**COUNTY VACATION  
& SUBDIVISION STAFF REPORT****Date: September 2, 2010****NAME**

Pecan Grove Place Subdivision, Phase Two, Resubdivision of Lot 1

Request to vacate a 45' drainage and utility easement across Lot 1, and create four legal lots of record from the resubdivision of that lot.

# SITE PLAN

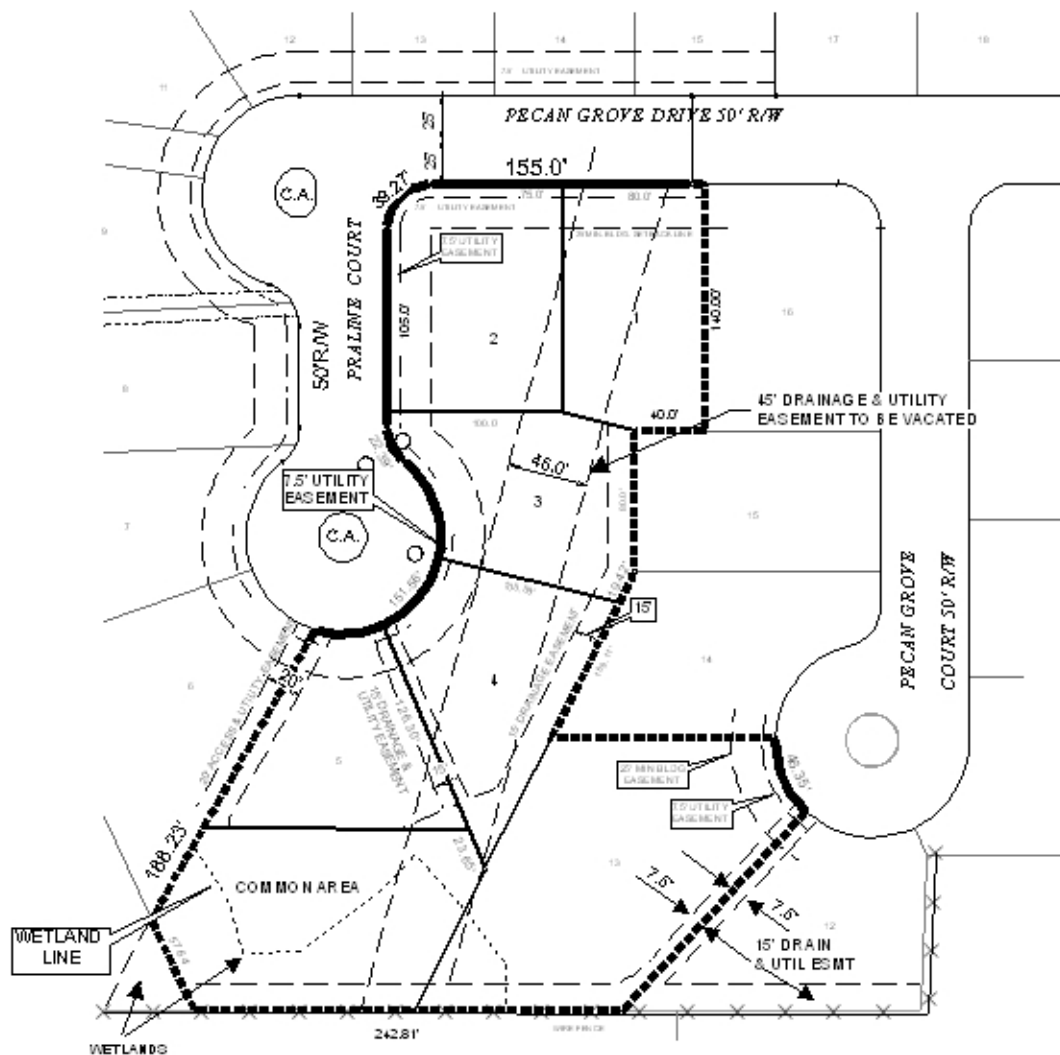
*The applicant submitted the required revised plat to include all properties on which the subject easement is recorded. With the inclusion of two additional recorded lots containing the easement, the subdivision now becomes a 6-lot subdivision instead of the originally-submitted 4-lot subdivision.*

*Regarding the creation of the four new lots from the Resubdivision of Lot 1, Pecan Grove Place Subdivision, Phase Two, all lots would meet the minimum size requirements as regulated by Section V.D.2. of the Subdivision Regulations. A table is furnished on the plat providing the lot sizes in square feet. The plat should be revised to label each lot with its size in both square feet and acres, or a table should be furnished providing the same information.*

*Proposed Lot 1 fronts Pecan Grove Drive with a compliant 50' right-of-way, and proposed Lot 2 fronts Pecan Grove Drive and Praline Court, also with a compliant 50' right-of-way. Lots 3, 4, and 5 front the central median cul-de-sac portion of Praline Court with a right-of-way diameter of 110'. As this was approved prior to the revision in April, 2008, of Section V.D.14. of the Subdivision Regulations requiring a 140' right-of-way diameter for central median cul-de-sacs, no dedication would be required. A note should be required on the final plat stating that Lot 2 (corner lot), is limited to one curb cut, with the size, design and location to be approved by County Engineering.*

*While the site is in Mobile County, it will have to comply with the City of Mobile storm water and flood control ordinances. A note should be placed on the Final Plat, if approved, stating that the*

*development will be designed to comply with the storm water detention and drainage facility requirements of the City of Mobile storm water and flood control ordinances, and requiring submission of certification from a licensed engineer certifying that the design complies with the storm water detention and drainage facility requirements of the City of Mobile storm water and flood control ordinances prior to the issuance of any permits. Certification is to be submitted to the Planning Section of Urban Development and County Engineering.*

- 1) revision of the plat to label each lot with its size in square feet and acres, or the furnishing of a table on the final plat providing the same information;*

- 2) placement of a note on the final plat stating that Lot 2 (corner lot), is limited to one curb cut, with the size, design and location to be approved by County Engineering;*

- 3) placement of a note on the final plat stating that the development will be designed to comply with the storm water detention and drainage facility requirements of the City of Mobile storm water and flood control ordinances, and requiring submission of certification from a licensed engineer certifying that the design complies with the storm water detention and drainage facility requirements of the City of Mobile storm water and flood control ordinances prior to the issuance of any permits. Certification is to be submitted to the Planning Section of Urban Development and County Engineering;*

- 4) placement of a note on the final plat stating that development of the site must be undertaken in compliance with all local, state and Federal regulations regarding endangered, threatened or otherwise protected species;*

- 5) *placement of a note on the final plat stating that any lots which are developed commercially and adjoin residentially developed property must provide a buffer, in compliance with Section V.A.8. of the Subdivision Regulations; and*
- 6) *placement of a note on the final plat stating that the maintenance of the Common Area is the responsibility of the property owners and not Mobile County.*
